INDESIT company

Model type:
AVSD127EX

Commercial code:
F029770

General notes

n1040325: New shock absorber fixing system with pin

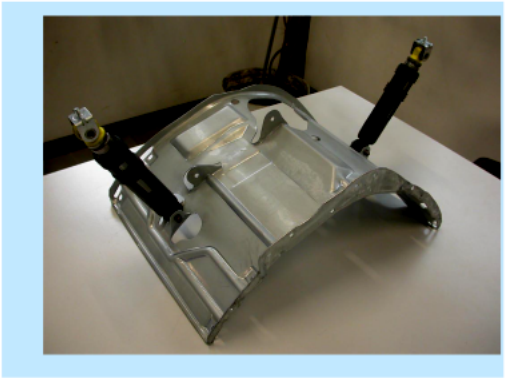
From serial no. 40427.0001, shock absorbers have been fixed to the tank unit cradle with two 11 mm pins code C00110163 (see fig. 01 and 02 enclosed) in place of the 8 mm screws code 093750 and relevant locking nuts code 030443, on all washing

machines and dryers produced in the Comunanza factory.
The items affected by this modification are:
1) The cradles have the same Service code, as they can be used in place of the new ones after widening the shock absorber fixing holes to a diameter of 10 mm.
Code 093848 - Tank unit cradle 46 lt
Code 093878 - Tank unit cradle 40 lt.
2) The new shock absorbers, with fixing bushing having no s/steel spacer, are not managed as they are interchangeable with the premodified items (make sure they are CIMA type, as the managed items), fixed with M8 screws code 093750 and related locking nut code 030443 (see figs. 05 and 06).
Code 093884 - Shock absorber 80 N
Code 093885 - Shock absorber 100 N

To remove the shock absorber from the tank, first extract the pin with a few hammer taps (see fig.03) until it is aligned with the tank bracket and then pull it out with a pair of pliers (see fig. 04).
(To refit the shock absorber use a new pin. Insert the pin until the toroidal edge is aligned with the bracket.)

n1040326: Two-bearing mechanism on Slim range washing machines

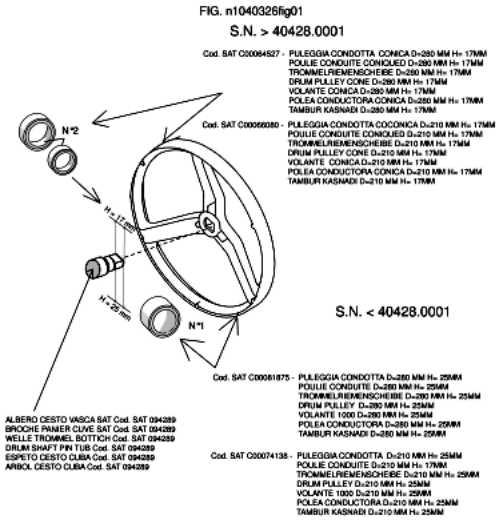
From serial no. 40428.0001, all Slim range models produced in the Comunanza factory have been equipped with a two-bearing mechanism in place of the single-bearing one.

The Service codes of the new mechanism are:
Service code C00096186 - SEAL RING CV4;
Service code C00002591 - BEARING 20X47X14 6204 SKF;
Service code C00013563 - BEARING 25 X52 X 15 6205 - 2Z SKF;
Service code C00110340 - CROSS WITH SEAL RING (2C) SNELLA;
Service code C00094289 - EVO 40L TANK SLIM (1-C) > (2-C)EVOII;
Service code C00094290 - OUTER- SET 40 L.(1-C)>(2-C)EVOII;
Service code C00064527 - DRIVEN PULLEY CONE D=280 MM H= 17MM;
Service code C00066080 - DRIVEN PULLEY CONE D= 210 MM H=17 MM.

The tank assembly with the new two-bearing cross has the same Service code as the single-bearing one (C00094289); the latter will be available until stocks run out.
When replacing the tank, make sure that the value H (17 mm or 25 mm) of the basket cross shaft corresponds to the value H of the pulley (see Fig.001).

The following premodified items will continue to be used:
Service code C00026298 - BEARING BA2B 633667 30X60.03X37;
Service code C00039667 - SEAL RING;
Service code C00074137 - CROSS WITH SEAL RING;
Service code C00081875 - DRIVEN PULLEY D=280MM H=25MM;
Service code C00074138 - DRIVEN PULLEY D = 210MM H=25MM;
Service code C00026299 - SEEGER RING SB 60X1,5.

Fig . 001

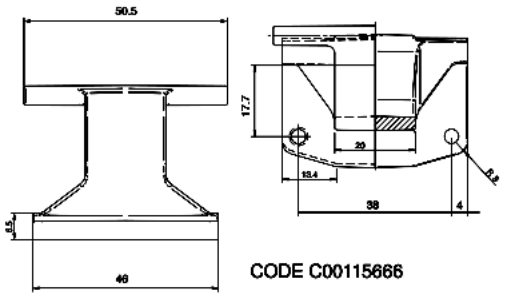
From serial no. 50207.0001, all Ariston models produced in the Comunanza factory (see table 001 attached) with industrial code (given on the rating plate) starting with 80, have been equipped with a Zamac hinge with 150° opening angle, code C00115666 (see Fig.001).
This modification has involved the introduction of the following items:

Code C00115670 - Complete door EVOII 150° white 27 with standard glass;
Code C00115674 - Complete door EVOII 150° white 27 with long glass;
Code C00115668 - Complete door EVOII 150° silver with standard glass;
Code C00115673 - Complete door EVOII 150° silver snella standard glass;
Code C00115662 - EVOII body for 150° hinge white 27
Code C00115663 - EVOII body for 150° hinge silver 27
Code C00115664 - Snella EVOII body for 150° hinge white 27
Code C00115665 - Snella EVOII body for 150° hinge silver

The premodified items are not interchangeable separately with the modified ones.

Fig . 001

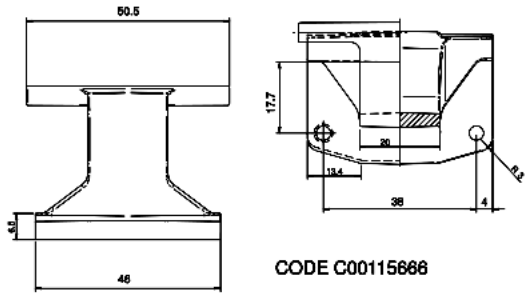
From serial no. 50315.0001, the new "Polar White" colour is used on all washing machines and washer-dryers produced in factory 80 in place of White 27.
The third last number of the Industrial Code given on the rating plate of the modified models is 9 (e.g. 80286390900).

To determine the new Polar White codes, it is necessary to know the industrial code or serial number of the appliance being repaired.
The new items, which bear the initials "PW" in place of "B27", are not aesthetically interchangeable with premodification items as the whites are different. Both colours will be available for some time.
The items affected by this modification are:
Body, rear panel, top, control panel, handles, buttons, knobs, knob disc, door and plinth.
